## Airworthiness Directive Issuance Form

**[Docket No. FAA-2016-9418; Product Identifier 2016-NE-23-AD; Amendment 39-19167; AD 2018-02-14]**

### **Airworthiness Directives; Honeywell International Inc. Turboprop and Turboshift Engines**

**ACTION:** Final rule.

**Figure 1 to Paragraph (h) of this AD. Combustion Chamber Case Assembly**

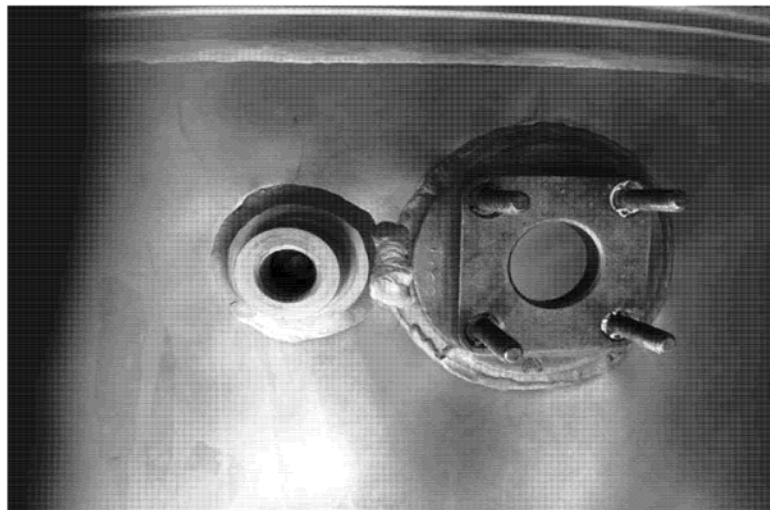
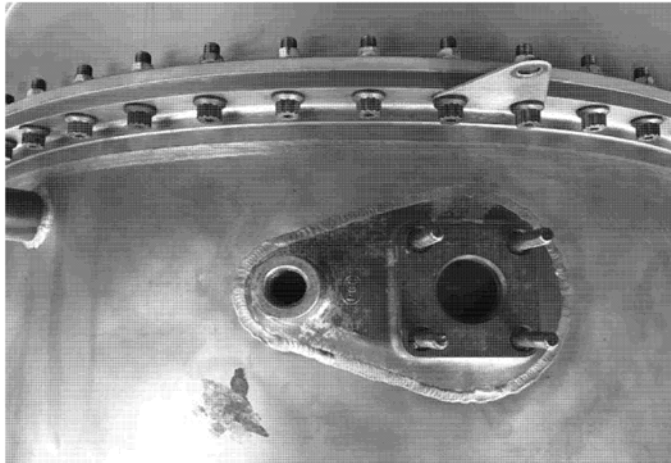
Perimeter Aviation LP (Perimeter) requested we add information to this AD regarding the number of failures of combustion chamber assemblies with or without the one-piece bleed pad. Perimeter requested further information on how these failures relate to the P/N 3101668-12 combustion chamber assembly.

We agree. We note that five of the six combustion chamber case assemblies that ruptured were assemblies without the one-piece bleed pad. P/N 3101668-x has the one-piece bleed pad with P3 boss, which demonstrated significantly reduced cracking between the P3 and bleed boss; therefore, this combustion chamber case assembly is not affected by this AD. No further changes are needed. We did not change this AD.

TPE331 model engines modified by STC SE383CH may be defined as the “Super 1” and “Super 2” for the compressor modification of the TPE331-1 and the TPE331-2, -2U, and -2UA engines, respectively. Figures 1 and 2 to paragraph (h) of this AD illustrate the appearance of combustion chamber case assembly, P/N 893973-5, without and with, respectively, the one-piece bleed pad with the P3 boss.

After the effective date of this AD, do not install a combustion chamber case assembly, P/N 869728-1, 869728-3, or 893973-5, in TPE331-3U, -3UW, -5, -5A, -5AB, -5B, -6, and -6A engines or in TPE331-1, -2, and -2UA engines modified by National Flight Services, Inc., STC SE383CH, unless the combustion chamber case assembly has a one-piece bleed pad with P3 boss.
